PLANNING BUREAU CASE REPORT

Preliminary/Final Lot Consolidation Plan & Land Development Plan Application 1933 & 1951 Herr Street

EXISTING CONDITIONS
1933-1951 HERR STREET
HARRISBURG, PA 17103

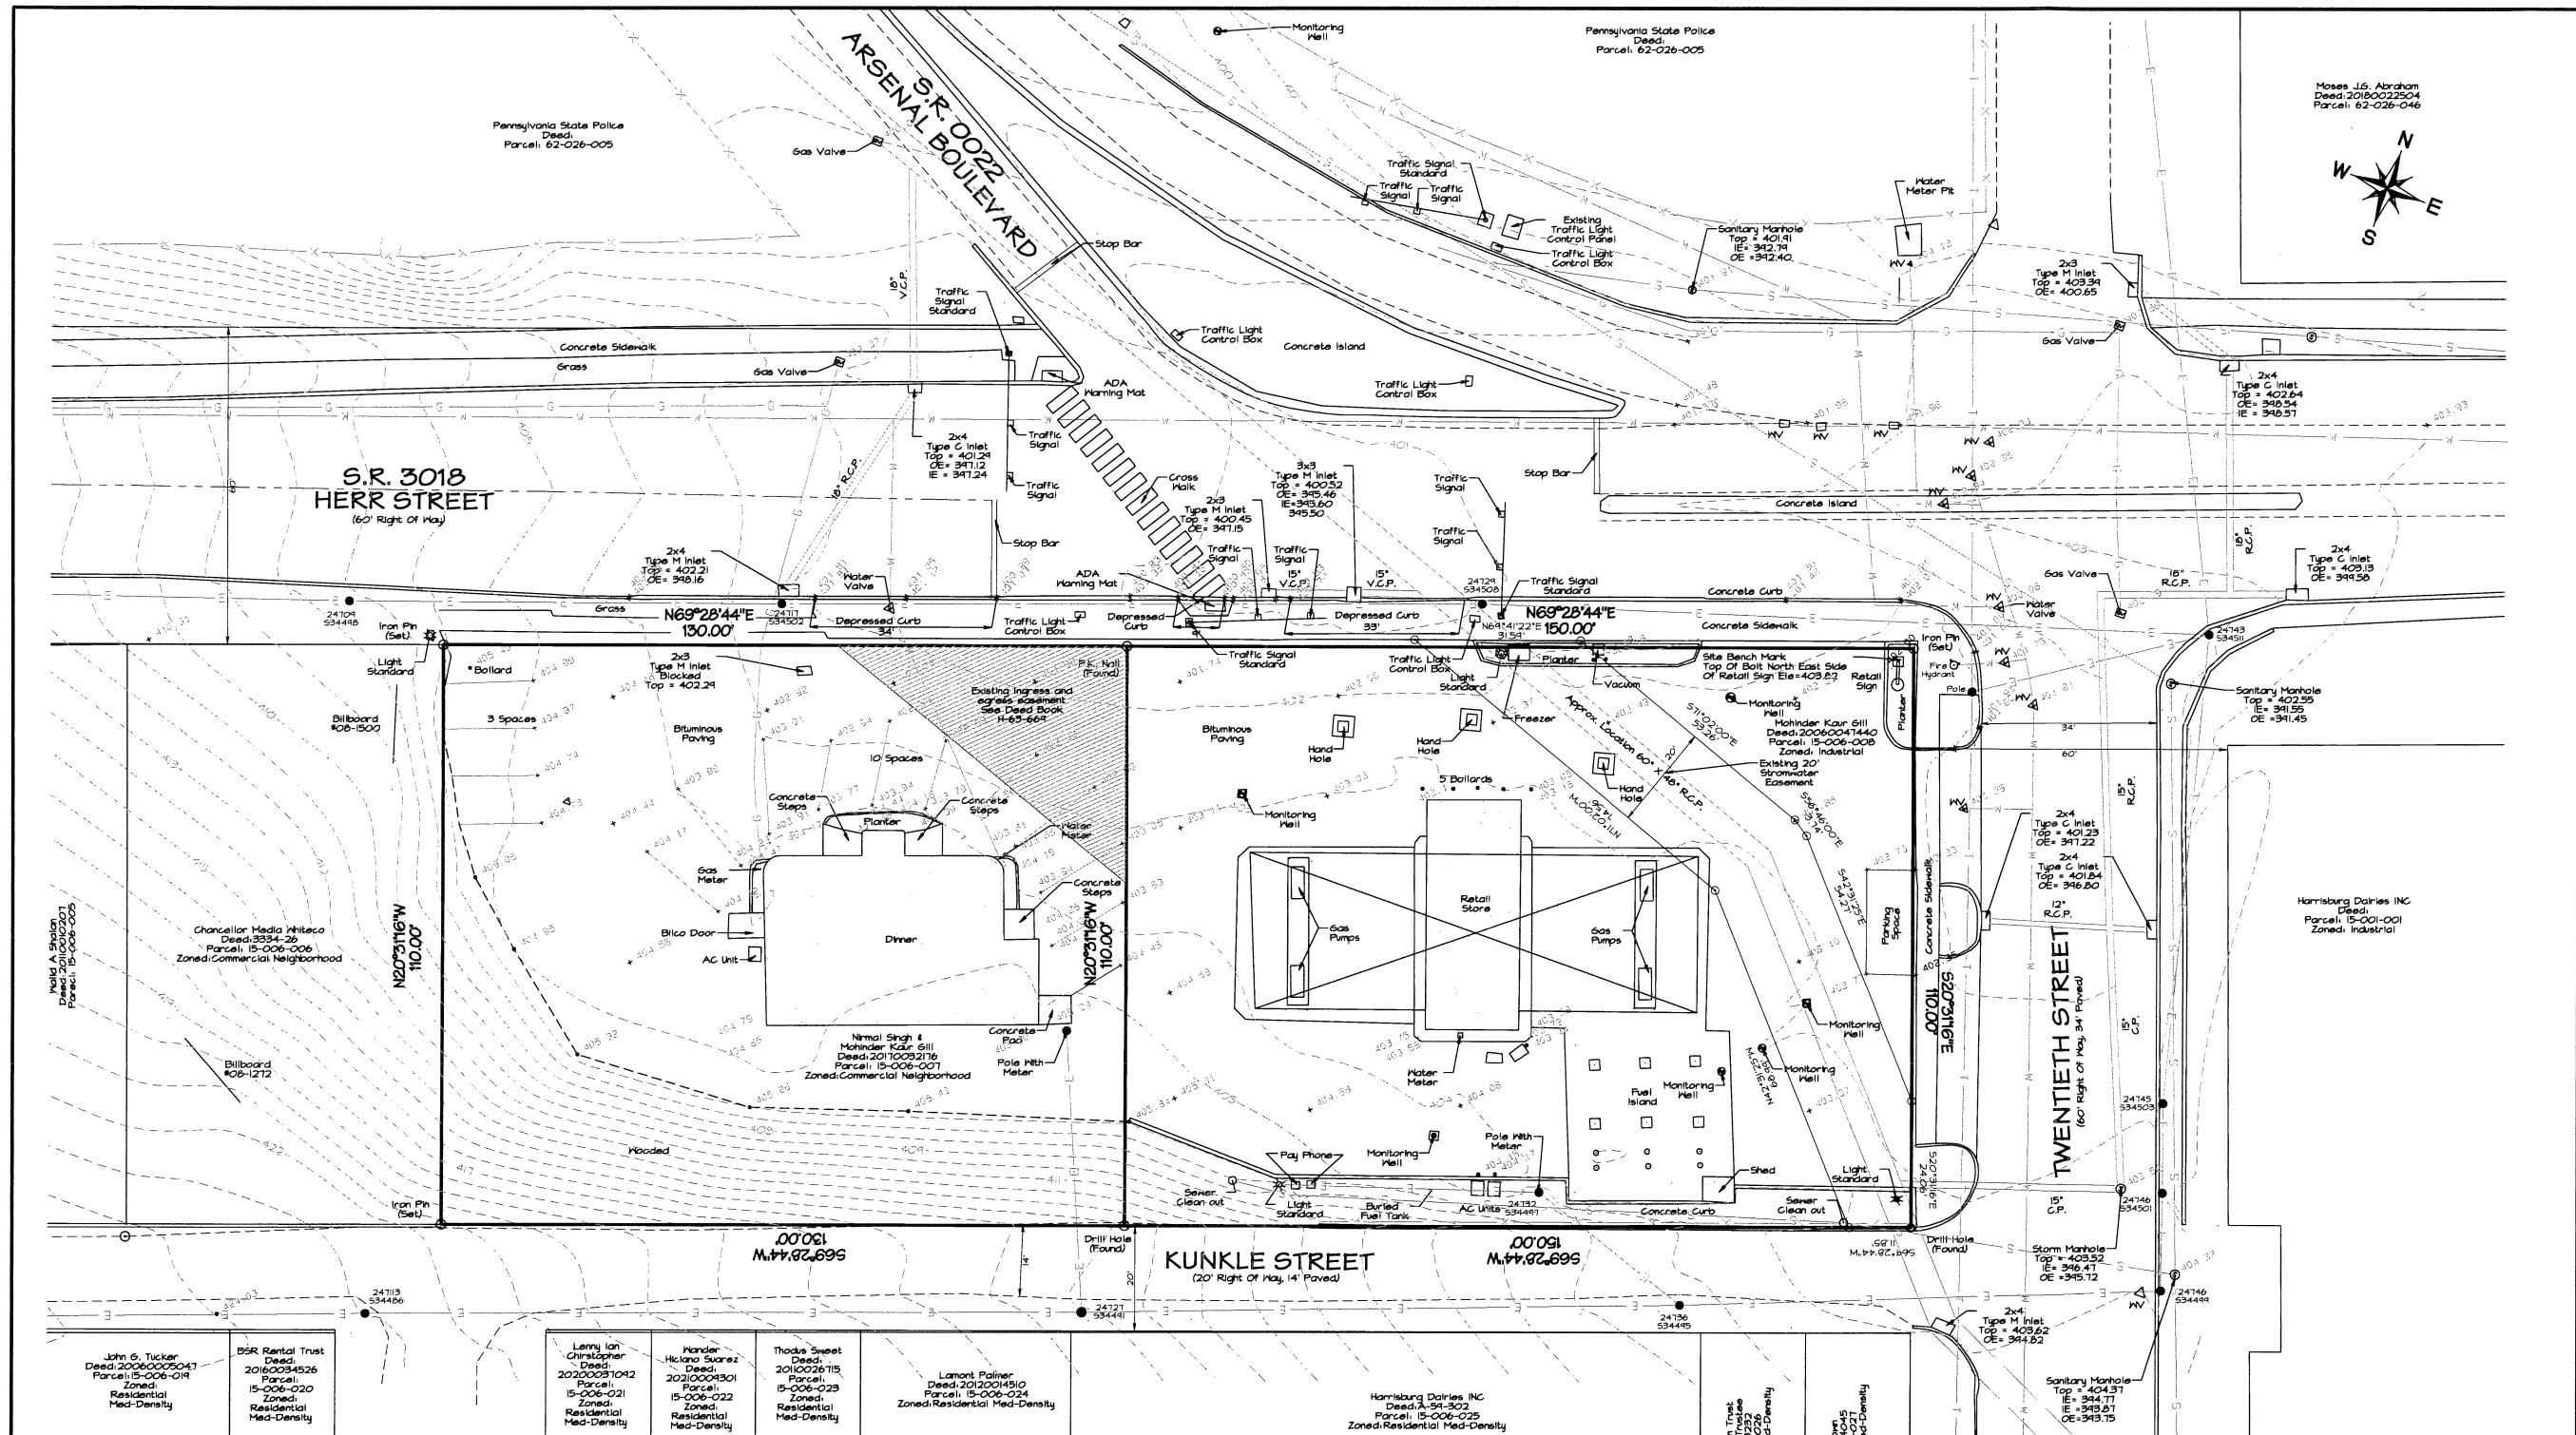
6. [§ 7-505.1.E] - Sheet LD2 does not have a written and graphic scale.
7. [§ 7-505.1.H] - Add proposed topography for all areas proposed for disturbance. Include spot elevations at critical locations where contours may not adequately describe the proposed surface (LD5).

8. [§ 7-505.3.A] - The plan should be drawn at a scale of 30 ft to the inch. However, other scales may be used if appropriate with an approved waiver.
9. [§ 7-505.3.E] - On sheet LD2 the contours are labeled, but the labels are not legible. On sheet PC1 the southwest end of the site near the dumpster and electric vehicle charging stations several items are illegible due to overlapping text.

ILLUMINATION PLAN
1933-1951 HERR STREET
HARRISBURG, PA 17103

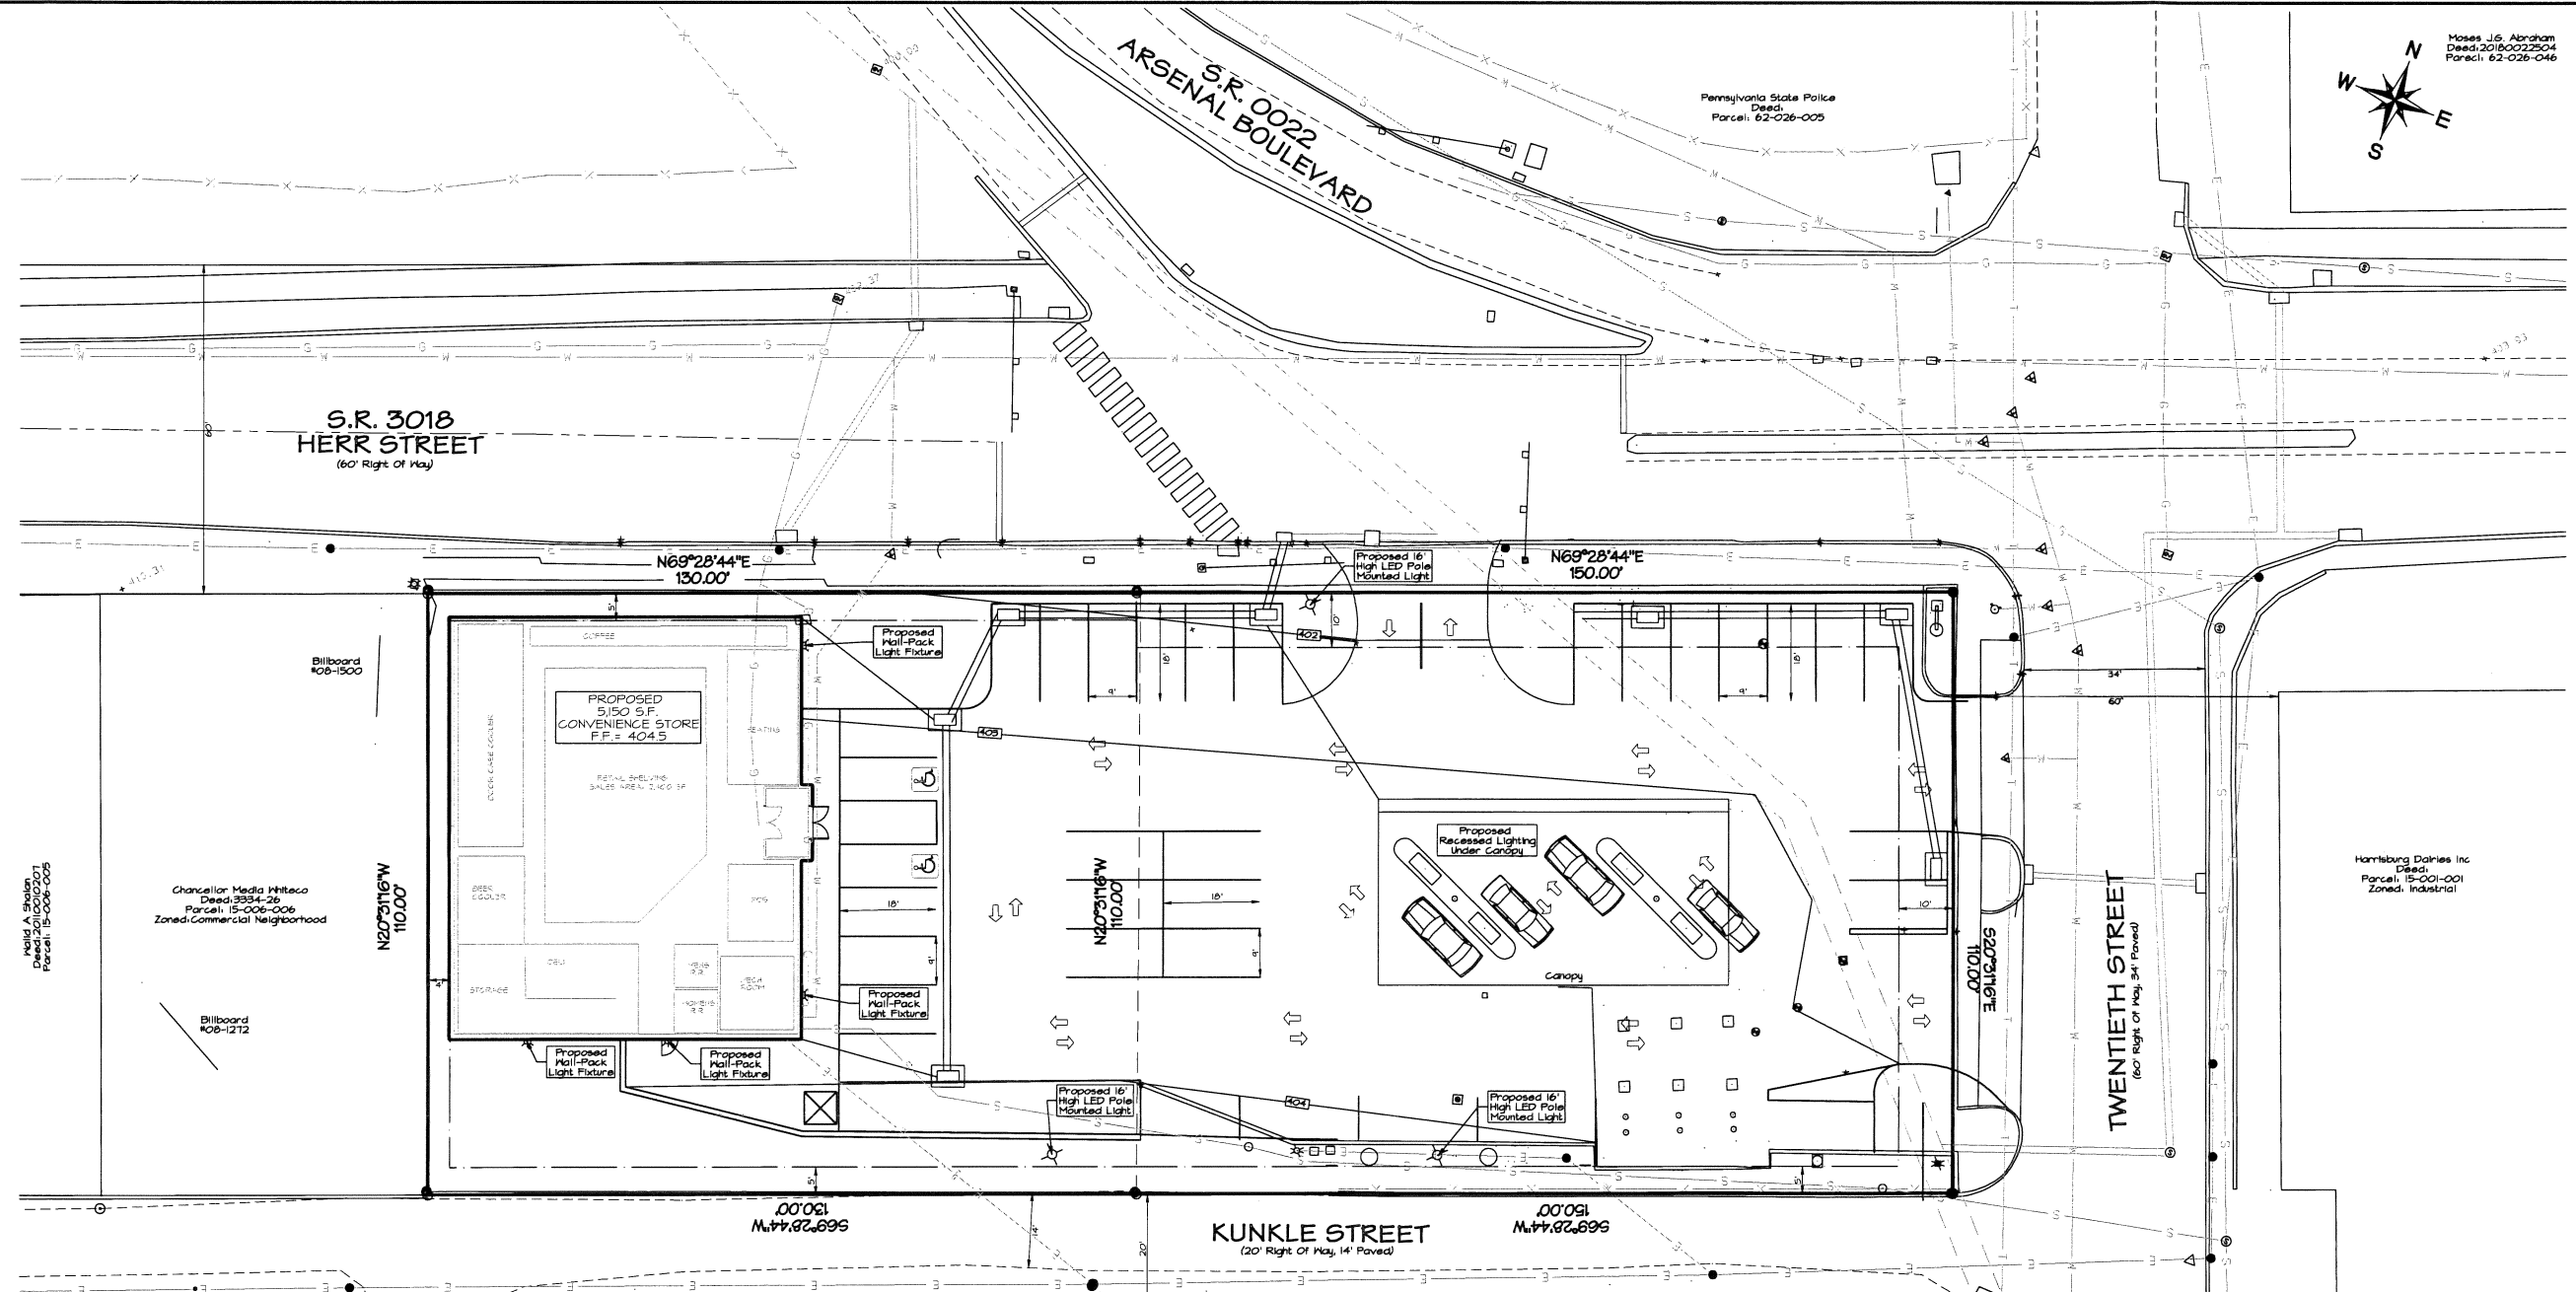
The Applicant has submitted an Illumination Plan (Sheet 8 of 8 in the Plan Set) which indicates that there will be four external lights around the perimeter of the building, as well as three new sixteen-foot-high LED light posts installed; however, the Applicants have not provided a photometric plan which indicates whether there will be any light spillover into adjacent properties. The Planning Bureau notes that a photometric plan is required to affirm whether the light generated by the project will conform to the Environmental Performance Standards regulations in Section 7-333.9 of the Zoning Code, or whether relief from those regulations is necessary.
